Land South of Lower Road, Bedhampton

Agreed Statement on Transport Matters

Client: Bargate Homes

i-Transport Ref: SJ/ITB12174-009C R

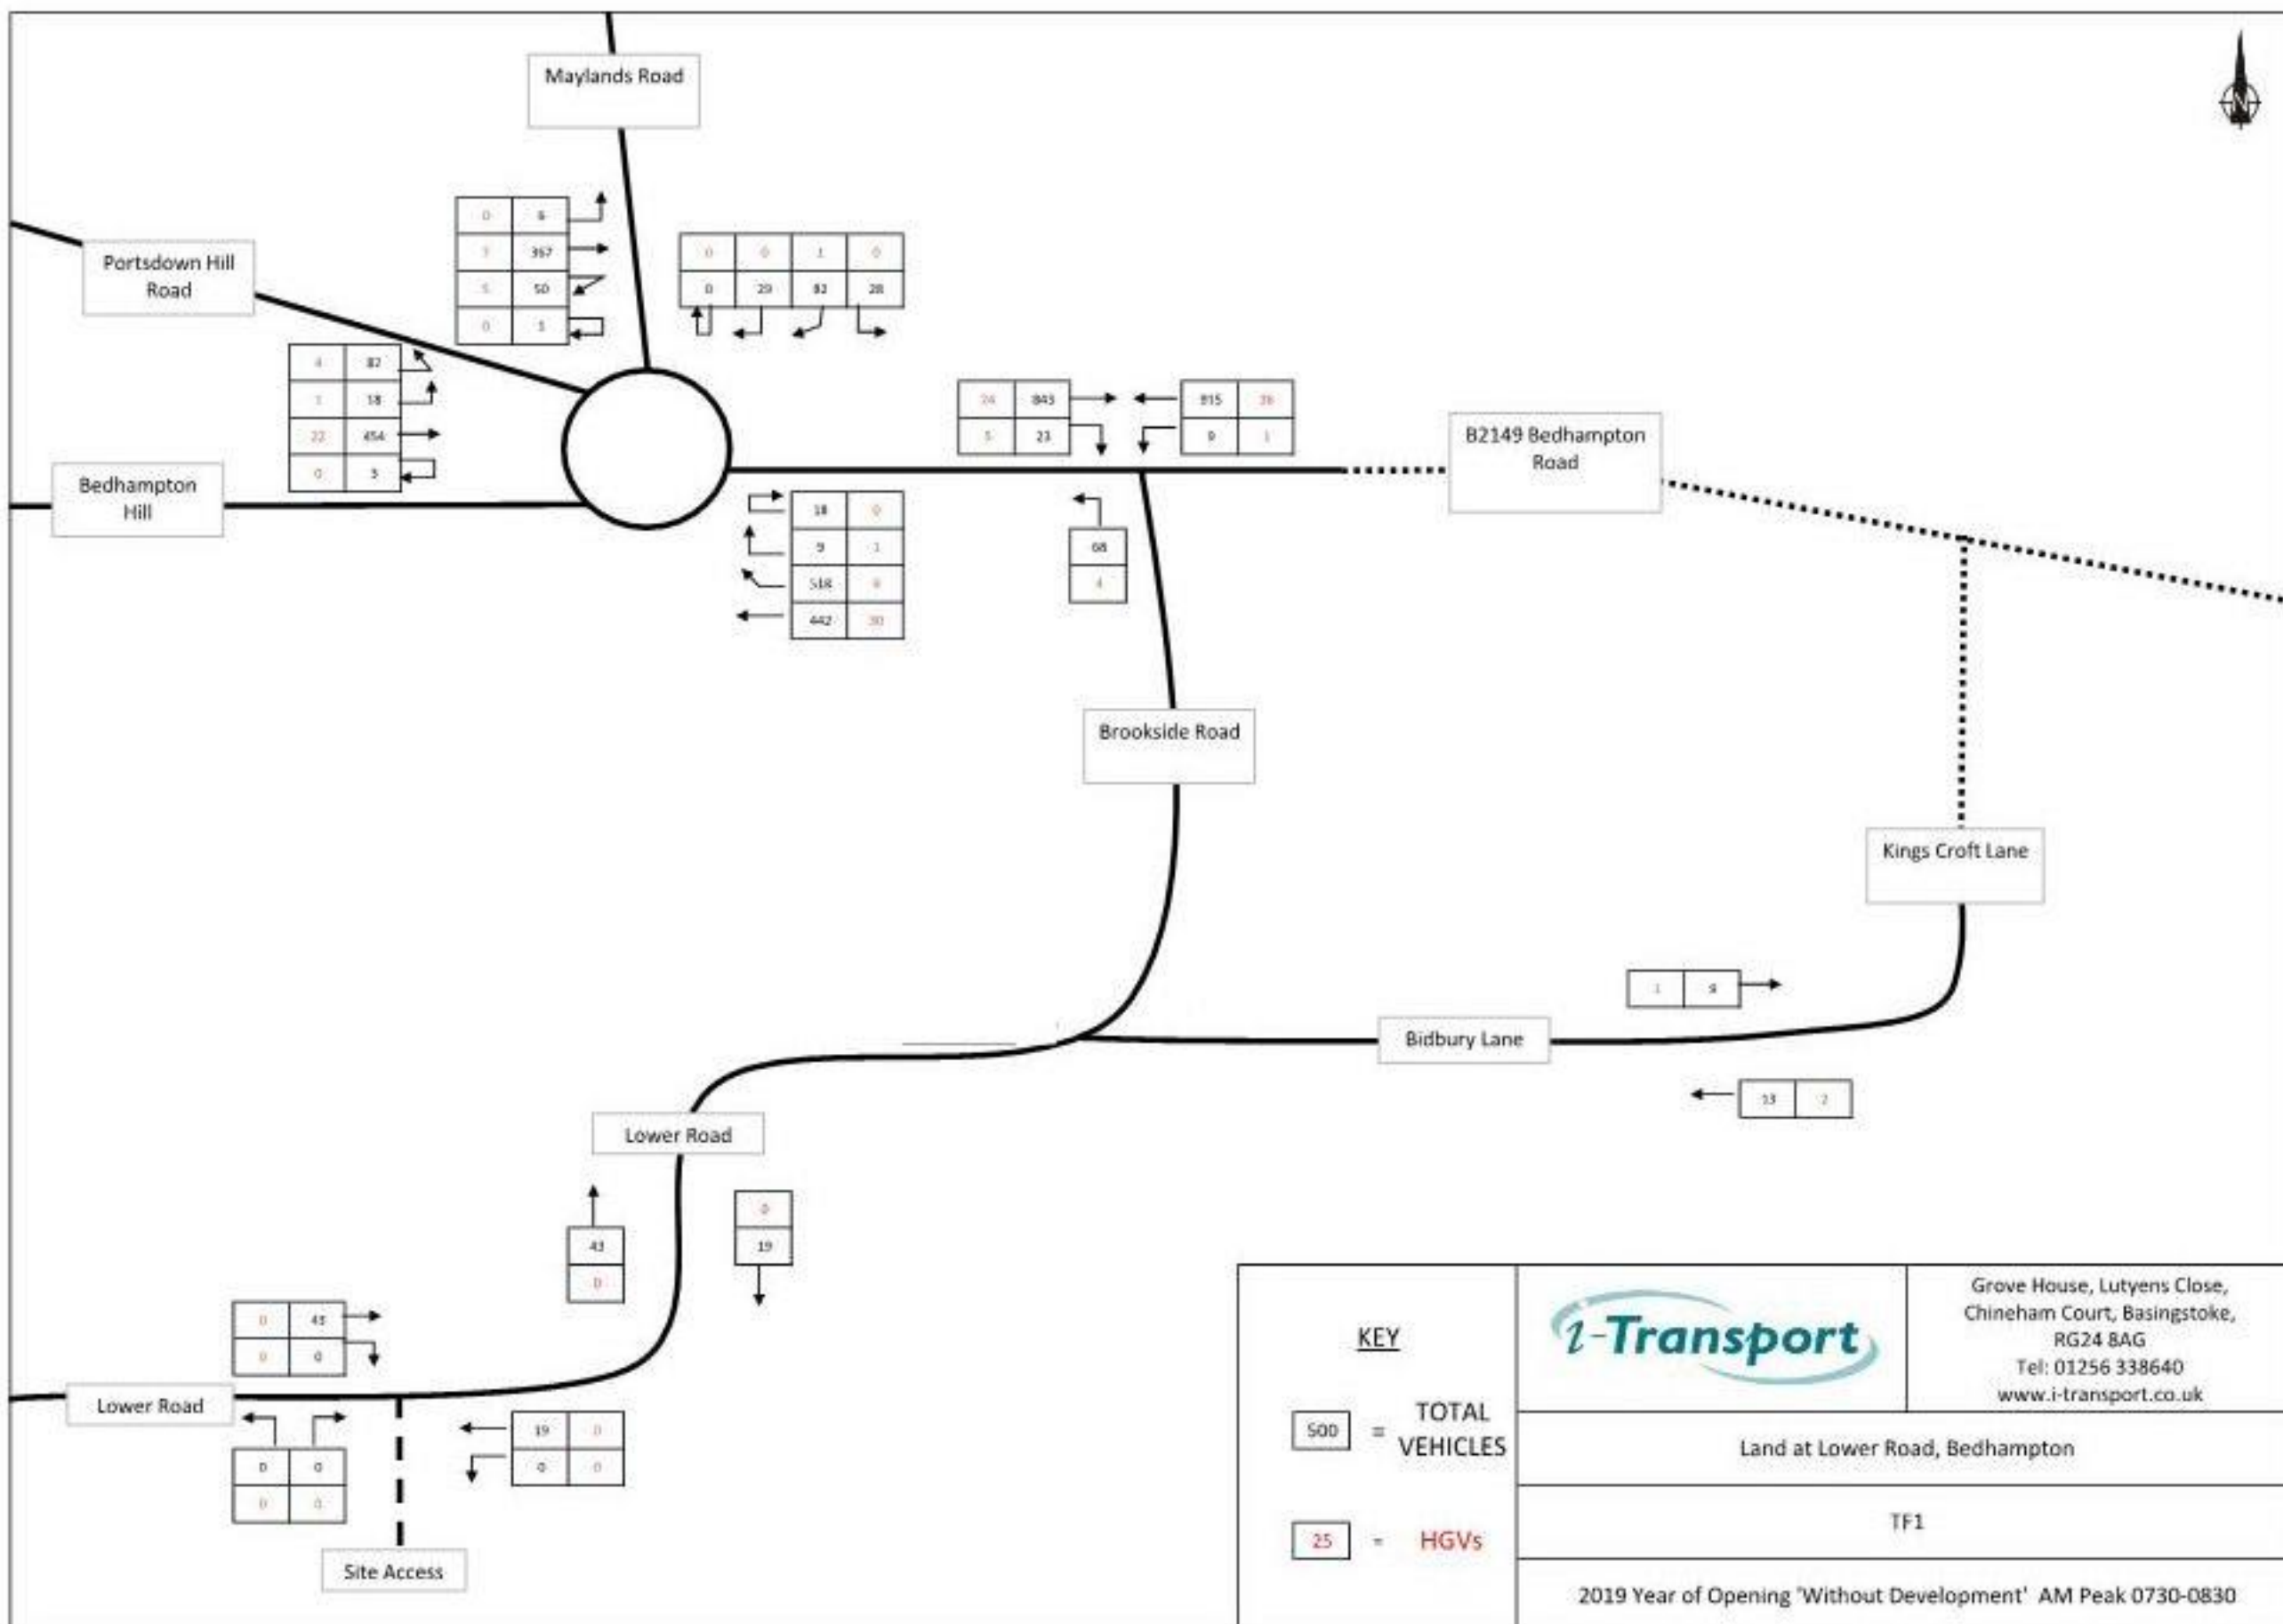
- 3.3.3 The agreed baseline traffic flows for the morning and evening peak hours are illustrated on **Figures TF1** and **TF2** respectively.

Drawing Number / Revision
102 - S

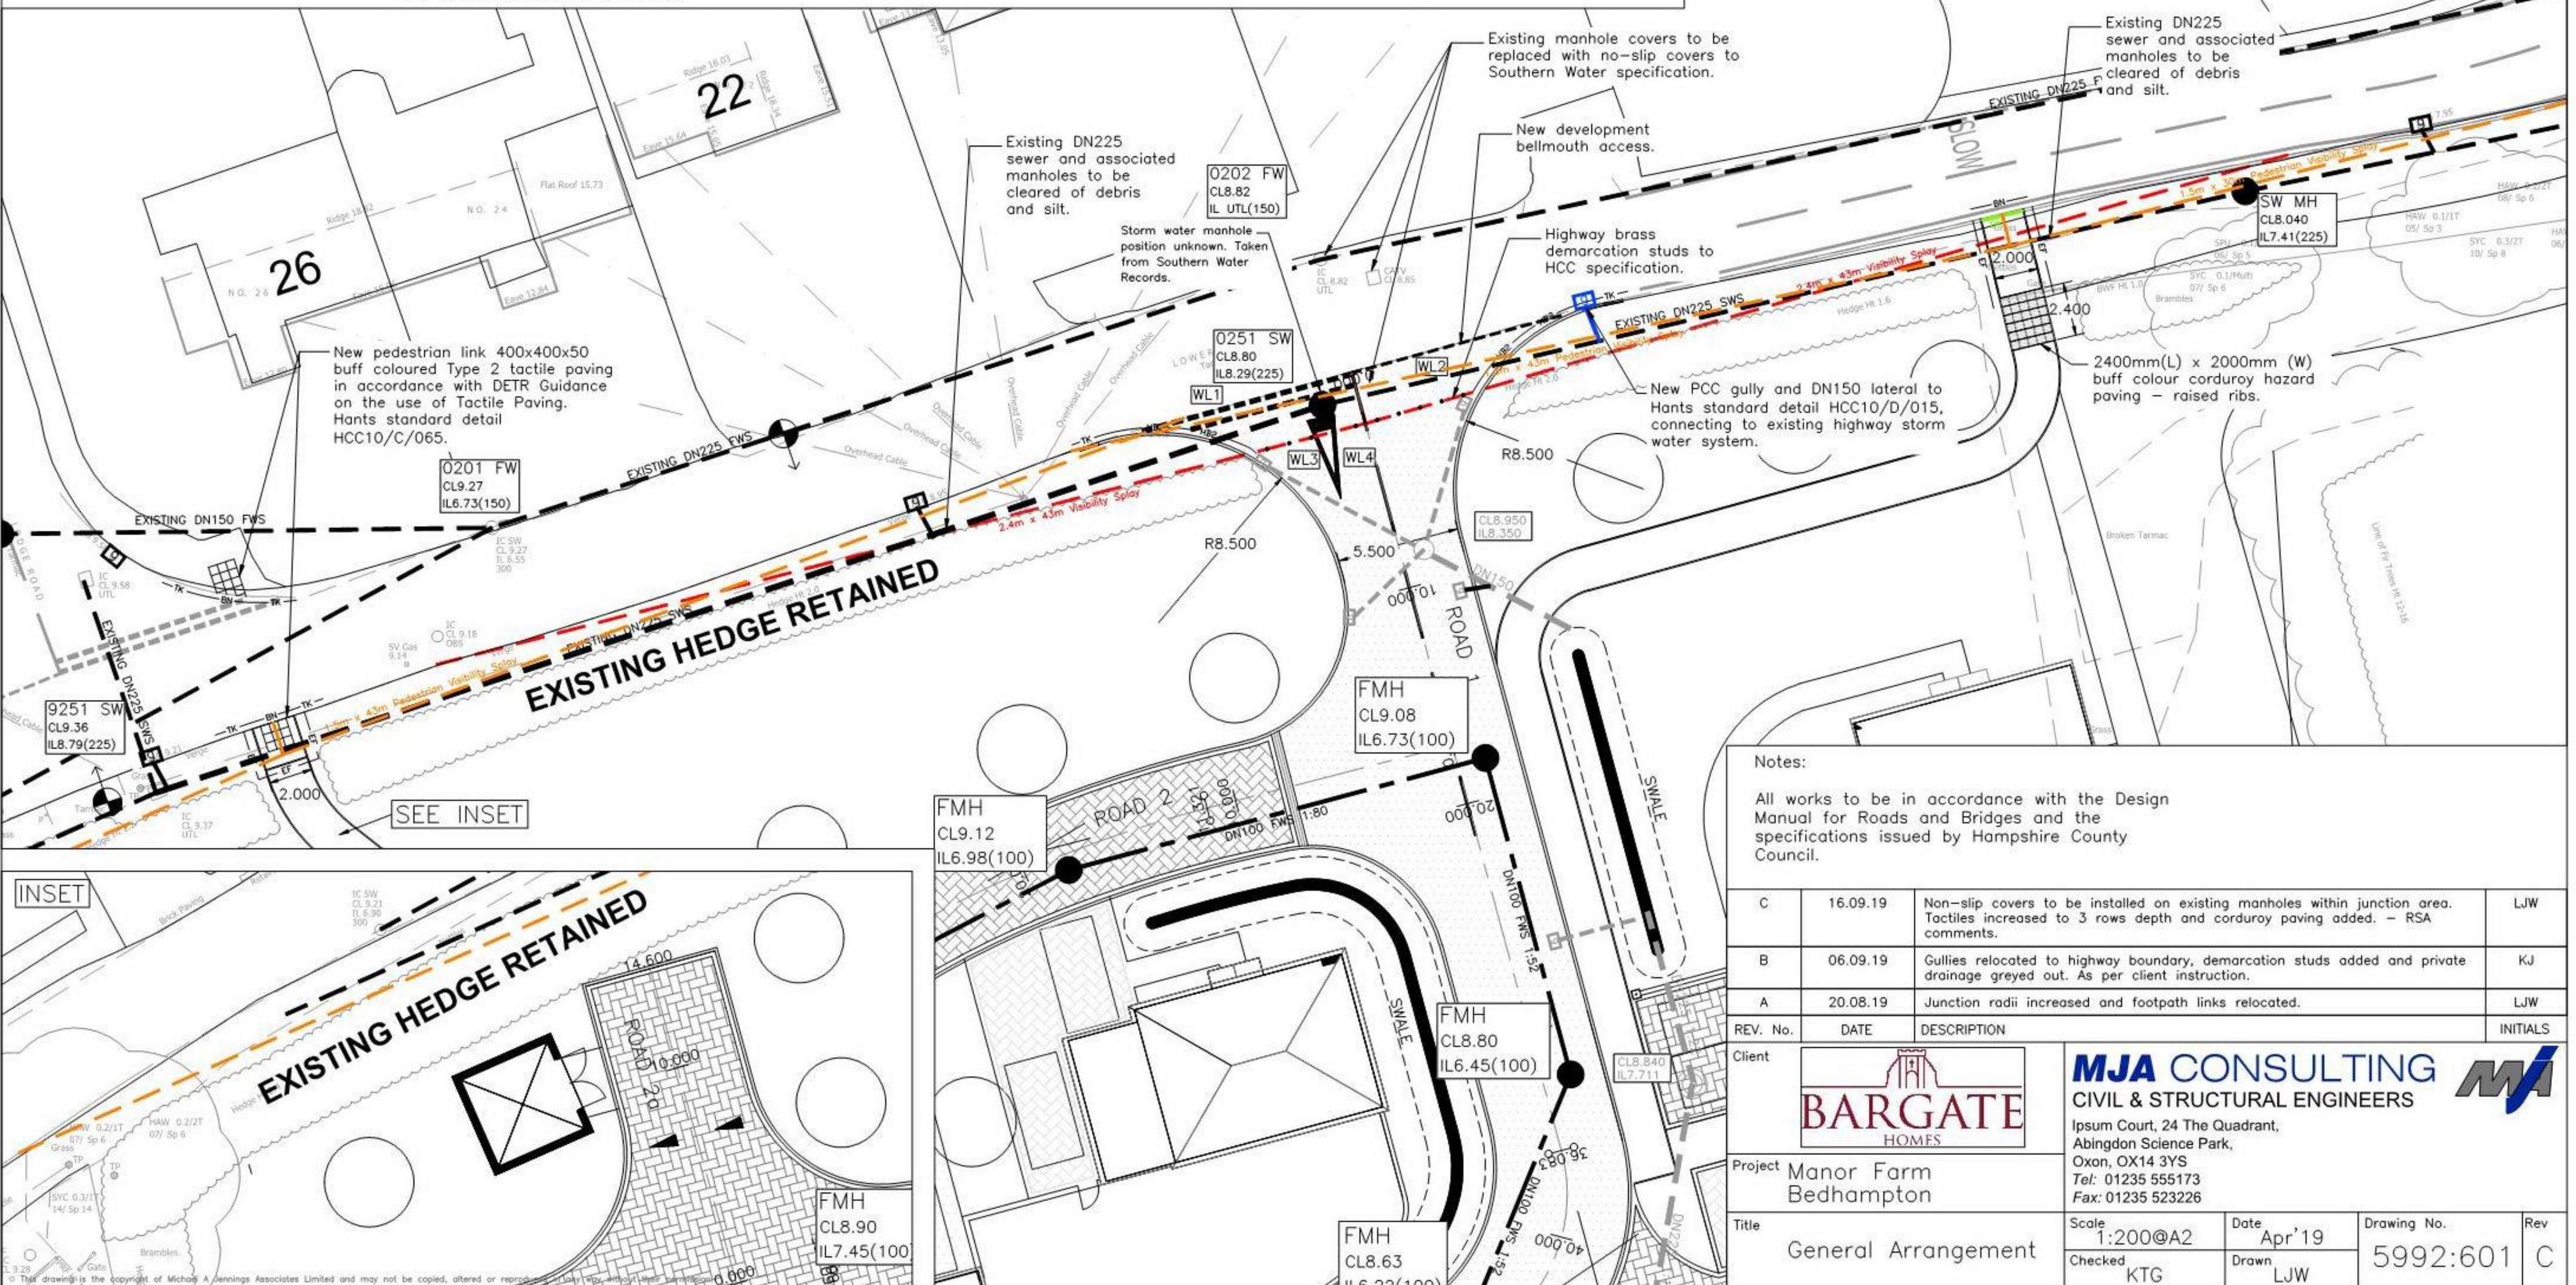
- 4.1.12 To consider the safety of the proposed access, a Stage 1 Road safety Audit (compliant with the relevant guidance at the time of submission) was completed. The auditors' recommendations were accepted and noted within the integral Designers Response.
- 4.1.13 In addition, a combined Stage 1 and 2 Road Safety Audit was completed in October 2019 in respect on the proposed on-site layout. The auditors' recommendations were accepted and noted within the integral Designers Response and the final site layout on **drawing 17.043 102 Rev S** reflects the changes required by the auditor.

An explanation of the double line just to the north of road 2, and adjacent to plot 15 would be appreciated.

The tracking drawing for a super large refuse vehicle in front of plot 10 would suggest the most southerly of the two trees shown is unlikely to last very long.

Revisions			
K-	Proposed site layout updated inline with planners comments: Plot 16&17, 42-46 House type amended. Plots 3-7, 10&11, 13-25, 40-46 Gardens updated. Footpaths to north of site, connecting site to lower road have been amended. Plot 48 Garage connected to Plot 47 garage. Plot 10-12 Carport Reduced. 3 bay car barns omitted.	13/08/19	TIM/MW
L-	Inline with clients comments & mark-ups received on 19th & 20th August 2019	28/08/19	TIM/HS
M-	Inline with clients comments & mark-ups received on 30th August 2019	03/09/19	IS/HS
